Hume Coal Project and Berrima Rail Project

Response to Submissions
Main Report

SSD7172 and SSD 7171 | Response to Submissions Report

Report J12055RP2 | Prepared for Hume Coal Pty Limited | 29 June 2018

Figure 9.2 Piper diagram for all baseline groundwater samples

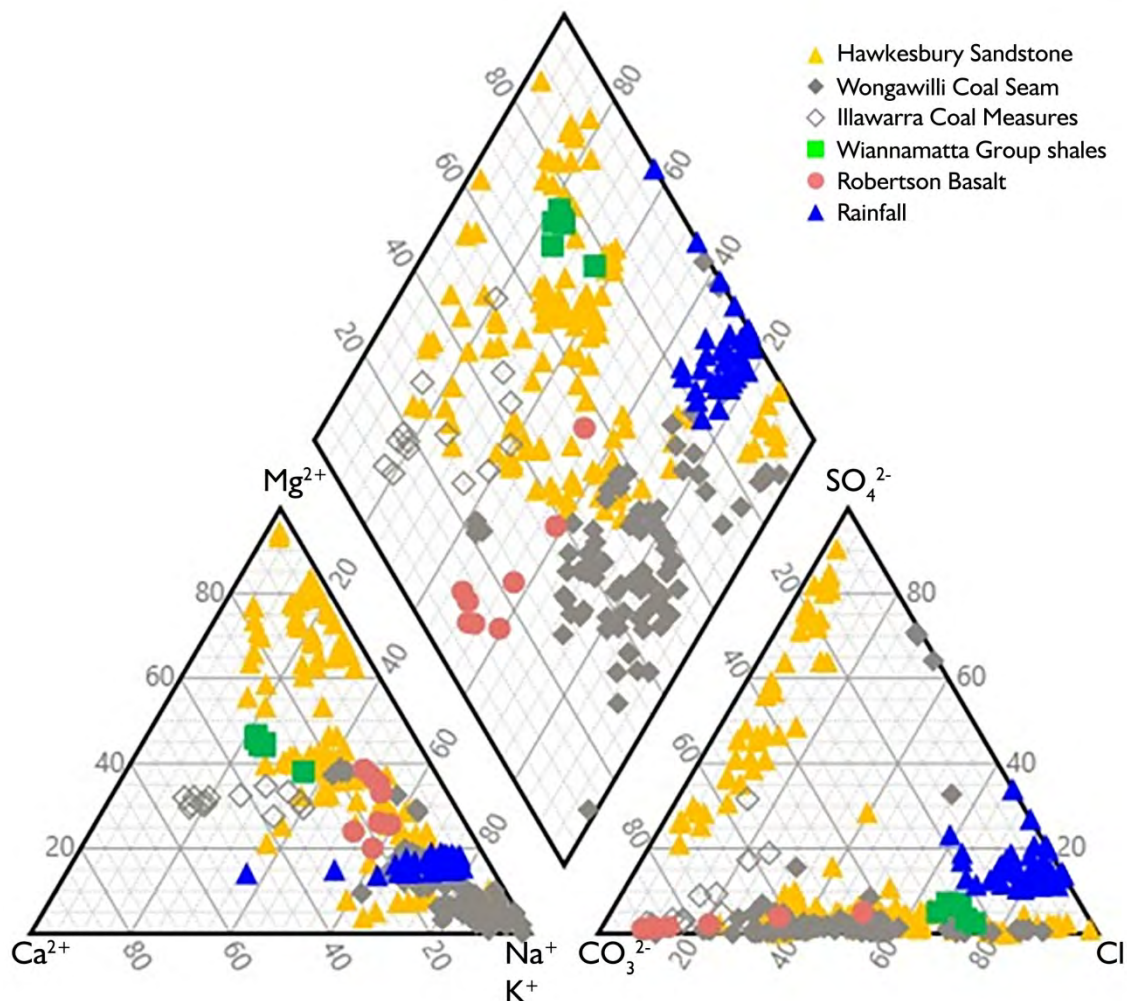
Presentation of the data has been considered following submissions and some of the key areas of concern have been reworked and re-presented in the revised Water Assessment, with some examples provided below (Figure 9.2 to Figure 9.6).

- piper diagram (Figure 9.2) including all of the baseline groundwater samples, rather than just the averages for each monitoring location (rainfall data have also been added to the plot for reference); and
- box plots of pH, electrical conductivity, sulfate and total alkalinity (as CaCO₃) for each of the major geologies (Figure 9.3 to Figure 9.6).

Figure 9.7 Comparison of measured versus calibrated hydraulic conductivity (from Coffey 2016a)

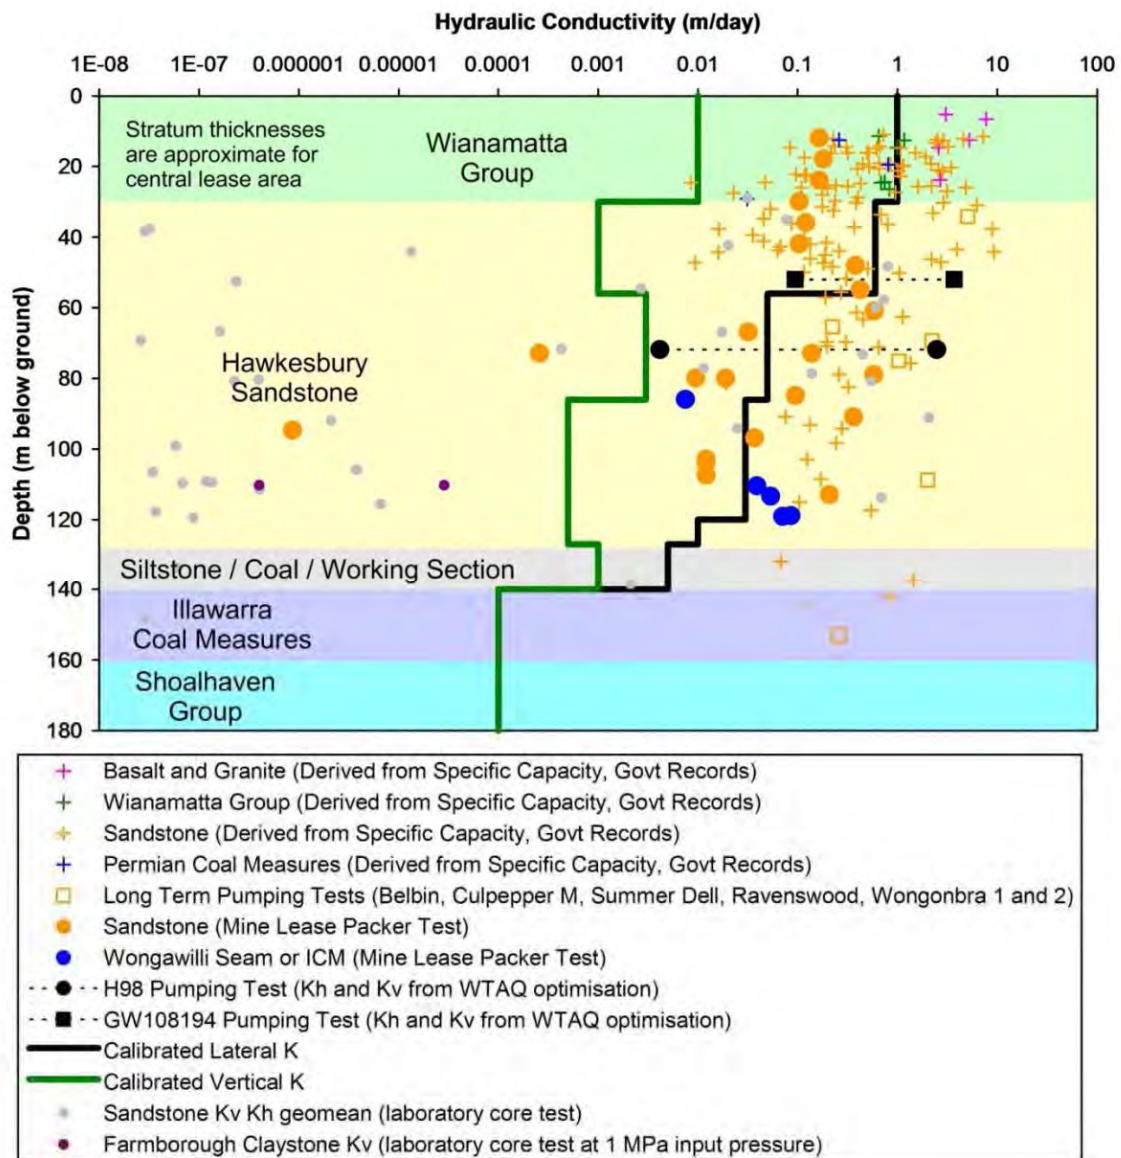
“The modelled Hawkesbury Sandstone Kh values are reasonable in that they lie in the middle of the range of observed values (Figure 9.7); clearly not at the high end of the range as suggested by Pells [and Pan] (2017), but also not at the low end of values (mainly from core testing, indicated by grey dots in Figure 9.7). Most of the pumping tests on individual bores (open square symbols in Figure 9.7) do indicate higher range Kh values, but that is for tests mostly in the higher elevations of the Hawkesbury Sandstone, including the two tests on bores on the Hume lease (H98 and GW108194 indicated by the solid black symbols). Again, the model reflects this effect of higher Kh in shallower units. The exception is the high Kh for the (un-named) bore at about 110m depth.”

The data presented in Figure 9.7 clearly shows a decreasing trend in hydraulic conductivity with depth in the Hume Coal project area and this part of the Southern Sydney Basin. The EIS numerical groundwater model has adopted parameters within the ranges of measured data for each depth, from the variety of tests undertaken. The Hume Coal EIS model adopted parameters for horizontal and lateral hydraulic conductivity are also illustrated on Figure 9.7.

Figure 9.8 Comparison of adopted versus theoretical storage values (revised from Figure 2.8 of Pells and Pan (2017))

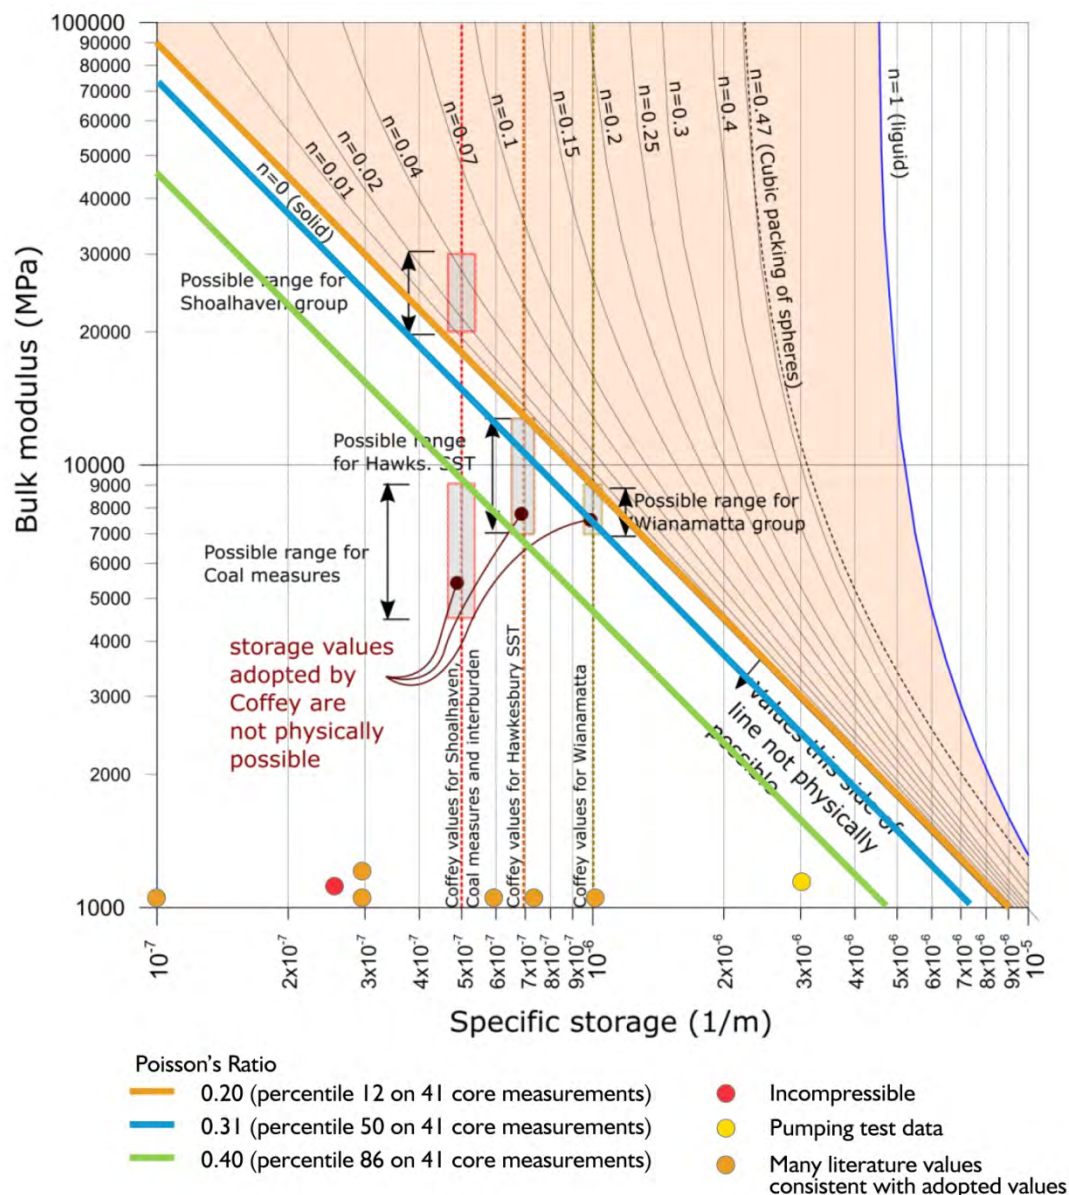
A replication of the figure from the interest group submission was undertaken where the storage values are challenged as being not mathematically possible (refer to Figure 9.8). Consideration of the Poisson's Ratio found that the values used for the Hume Coal model were consistent with literature values (represented as orange symbols in Figure 9.8), incompressible values (represented as red symbols in Figure 9.8) and pumping test results (represented as yellow symbols in Figure 9.8). This demonstrates that the values adopted in the Hume Coal model are appropriate.

Increasing the specific storage values made no practical difference to the SRMS statistic or the RMS statistic within the revised calibration model. However, the updated values are more closely aligned to field measurements and are therefore retained in the revised model.

Figure 14.5

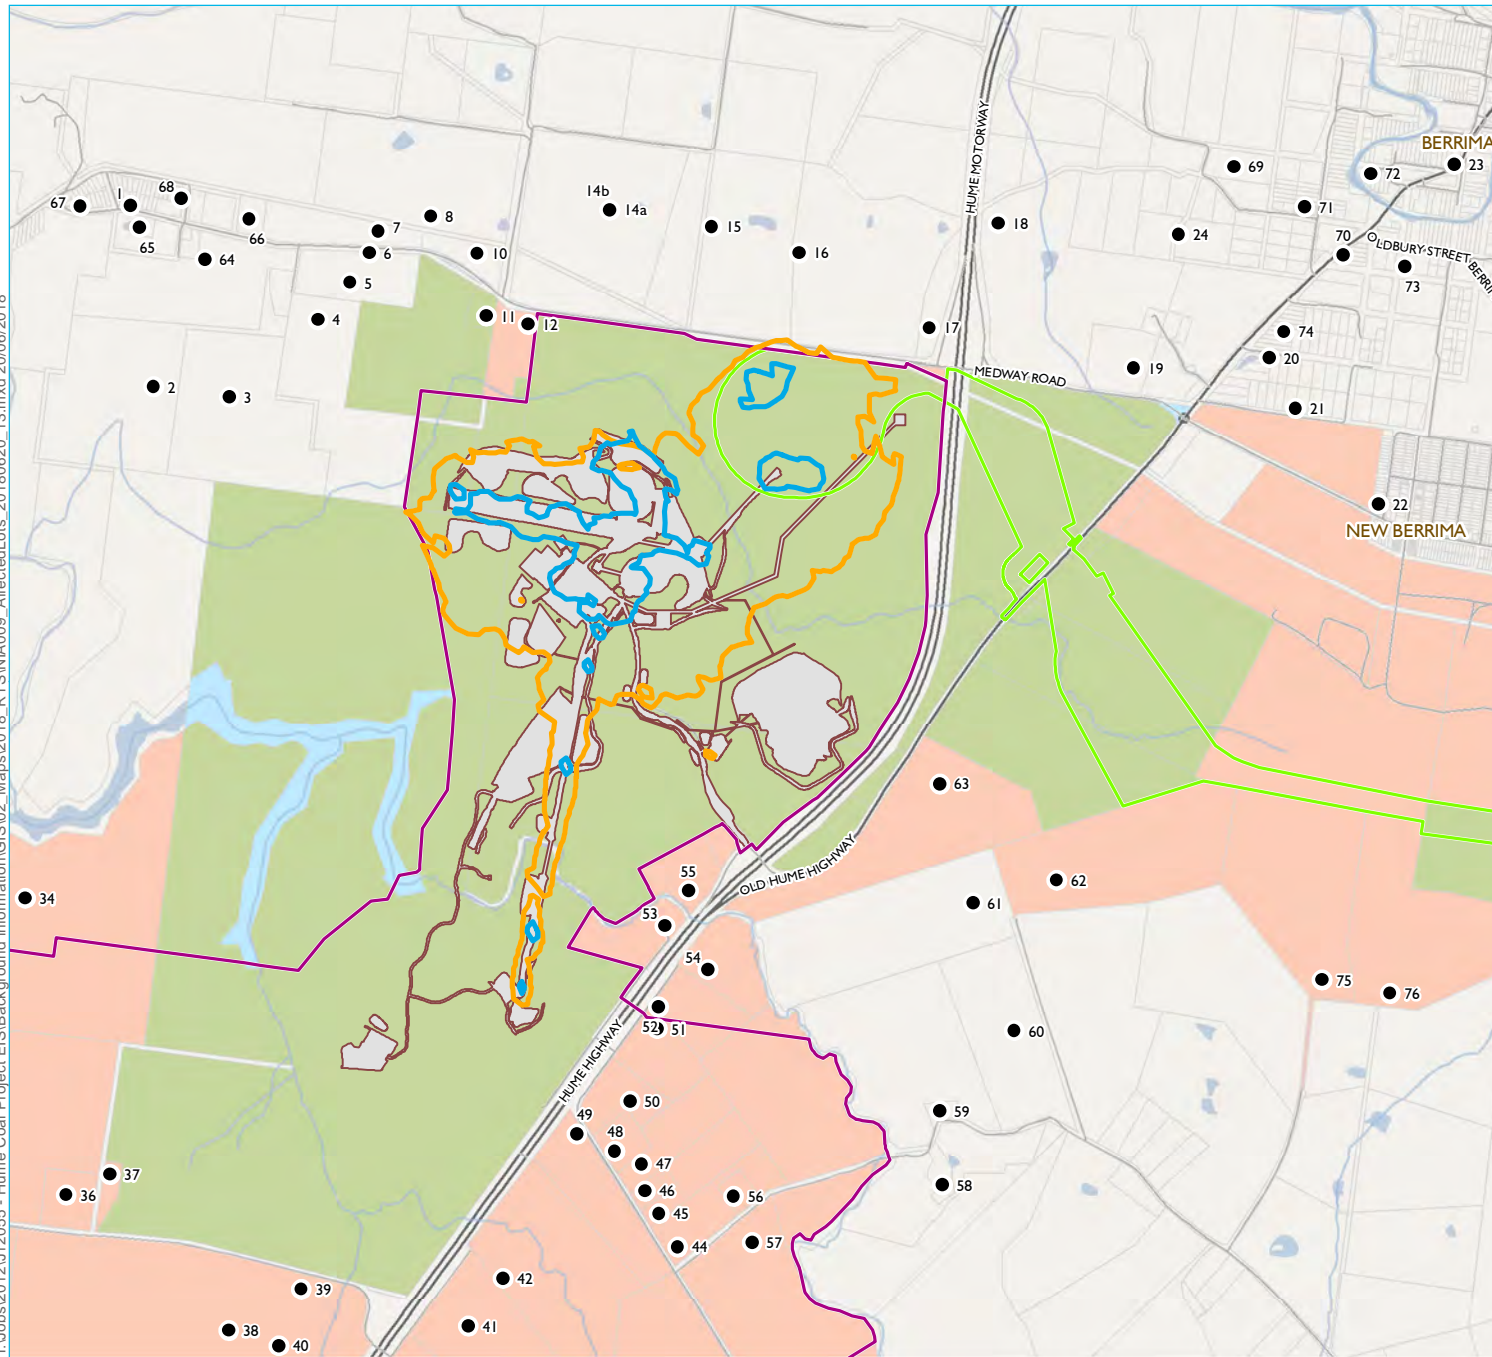
The $L_{Aeq,night}$ noise contour (shown in Figure 5.4 of the NVA report) was generated by modelling all surface infrastructure plant as listed in Table 4.2 of the Hume Coal Project NVA report. This includes the overland conveyor proposed between the surface infrastructure area and the mine portal access. The indicative sound power levels are shown in Table 4.2, and include 65 dB and 75 dB per lineal meter (modelled as a 'line' source) of conveyor for the east side and west side of the conveyor respectively. This difference is attributed to the proposed cover and sheeting on the east side of the conveyor.

The presented noise contours in Figure 5.4 have been checked by EMM and it is confirmed that these contours are correct. The issue raised in relation to the $L_{Aeq,9hour}$ night 45 dB noise contour in Figure 5.4 of the Hume Coal Project NVA report is related to the resolution of the grid used to develop the contour. The model and output for this contour plot has been further reviewed in response to this query.

The grid used for contouring was 200 m and the conveyor alone does not produce 45 dB $L_{Aeq,9hour}$ or higher at a 200 m offset from it. Hence, there needs to be grid points nearby in order for the contour to 'appear'. This happens part way along the conveyor, where a relatively small number of grid points exist near enough to the conveyor, resulting in the isolated noise contour shown. This contour figure has been reproduced to demonstrate this issue as shown in Figure 14.5.

Proposed elevation of the rail line overbridge across the Old Hume Highway

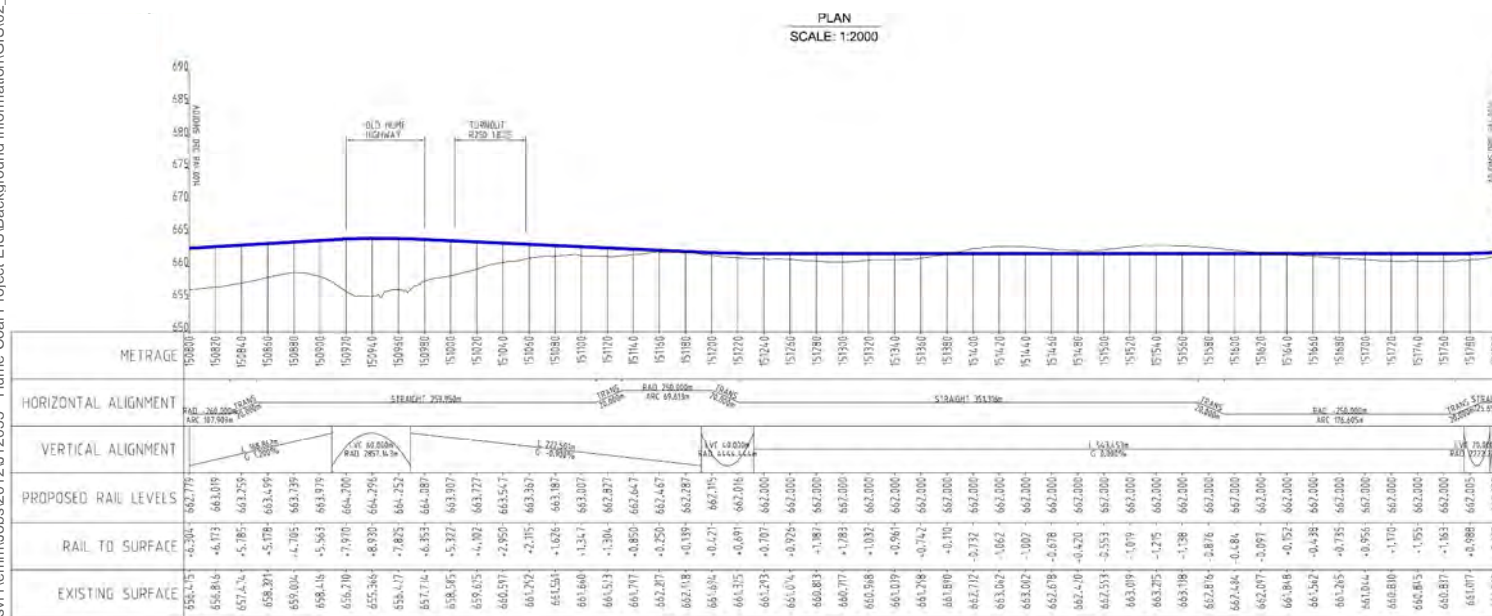
The Berrima Residents Association noted that no design details of the rail bridge over the Old Hume Highway are included in the EIS, and submitted that the rail bridge over the Old Hume Highway should be turned into a road bridge over the rail tracks.
